HISTORIC PRESERVATION BOARD STAFF REPORT

516 N. Swinton Avenue

Meeting	File No.	Application Type
August 5, 2026	HP-526-2026	Certificate of Appropriateness, Demolition, Variance, & Waiver

The item before the Board for consideration of a Certificate of Appropriateness (HP-526-2026), Demolition, Variance and Waiver requests for a second-floor addition to an existing non-contributing one-story garage structure for use as a guest cottage for the property located at **516 N. Swinton Avenue (Harden-Hart House), Individually Designated to the Local Register.**

SITE PLAN

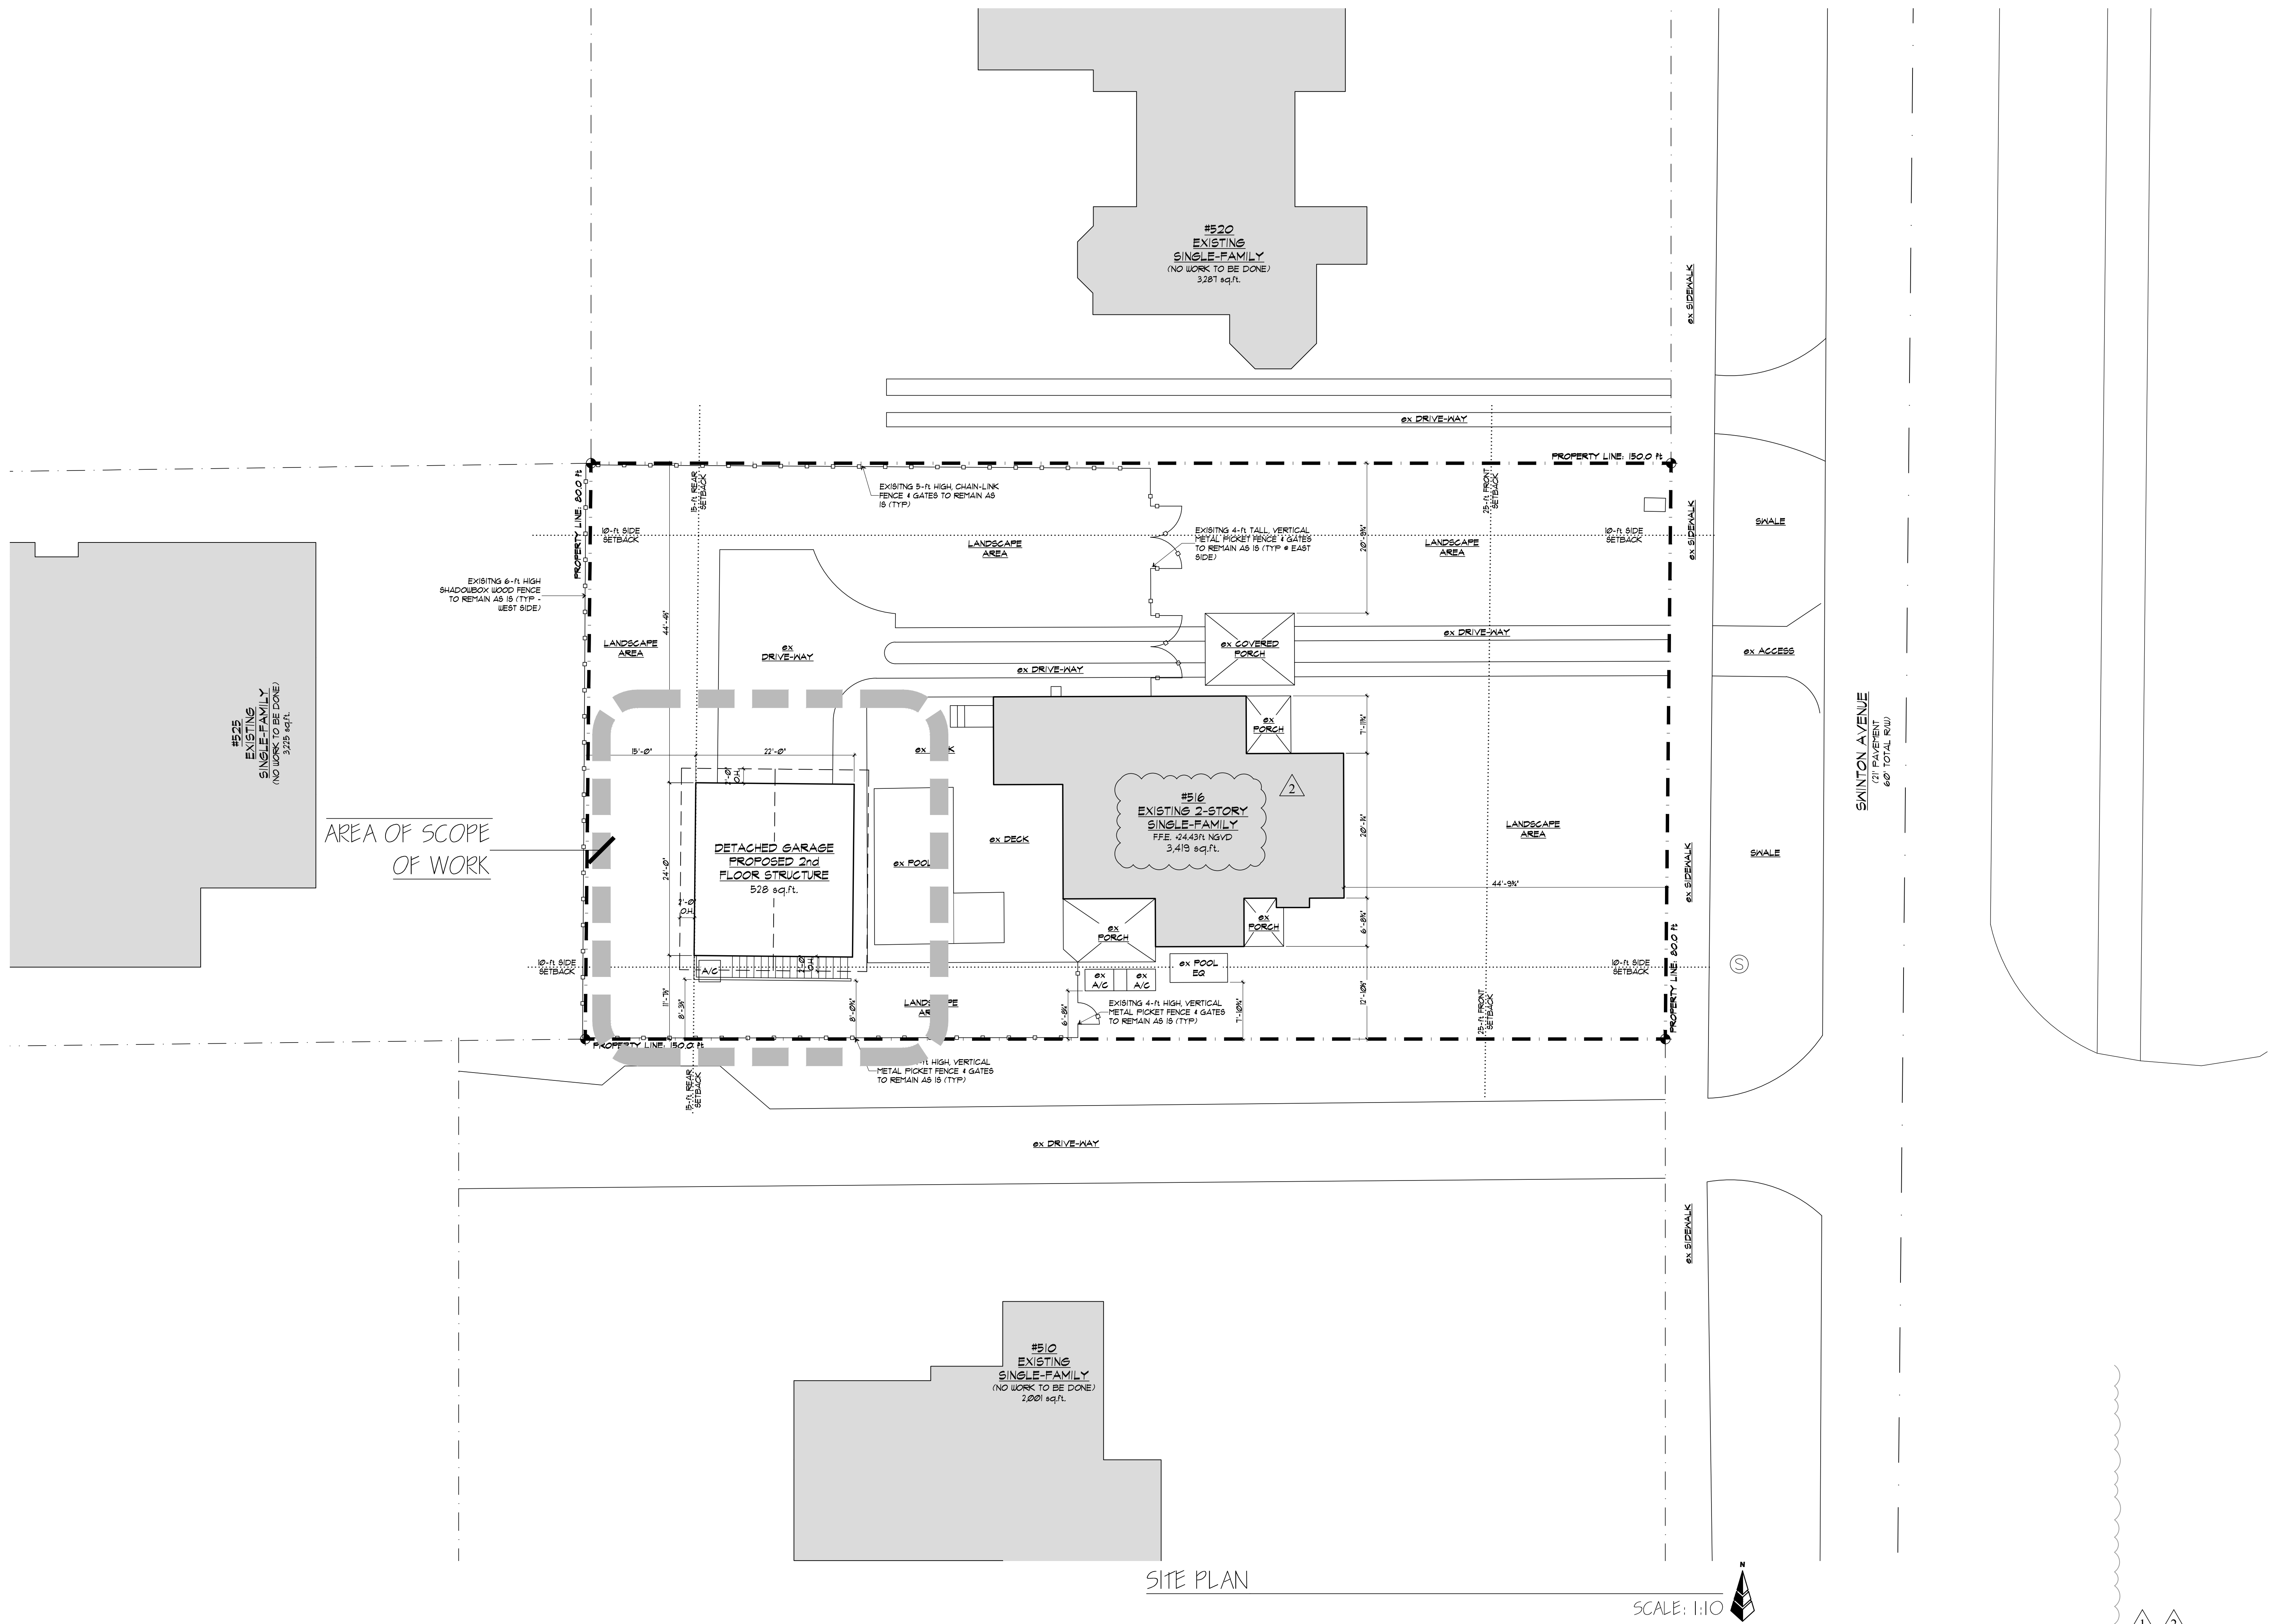
The variance request is for the installation of steps within the south side interior setback to access the proposed second story guest cottage. As this structure is non-contributing, and no modifications are proposed to the principal structure, the variance isn't necessary to maintain the historic character of the property. However, the variance does not appear to be contrary to the public interest, safety, or welfare, as the steps are proposed on an elevation that is not clearly seen from the public right-of-way and is located on the accessory structure that is substantially recessed from the front setback and behind the principal structure.

Literal interpretation of the code would require reconfiguration of the site to either modify the location of the garage entrance or remove the existing pool. It may also prompt a second accessory structure be placed on the site to accommodate the guest cottage that would then be highly visible from the public right-of-way, risking visual compatibility with the principal structure. The steps located on the south side require the least amount of site modification and would be the smallest variance option as the request is only for a portion of the steps, while the rear setback would be for the entirety of the steps within the setback.

The variance will allow portions of steps to encroach within the south side interior setback for the proposed second story guest cottage. While the historic main structure is not being altered with the proposal, the utilization of the non-contributing structure to accommodate a new addition, could be seen as aiding in the retention of the historic structure's appearance and building footprint with minimal visible changes to the streetscape elevation. The request is not necessary to accommodate an adaptive reuse of the historic structure, but it does provide an opportunity for expansion with minimal impact to the site/historic structure.
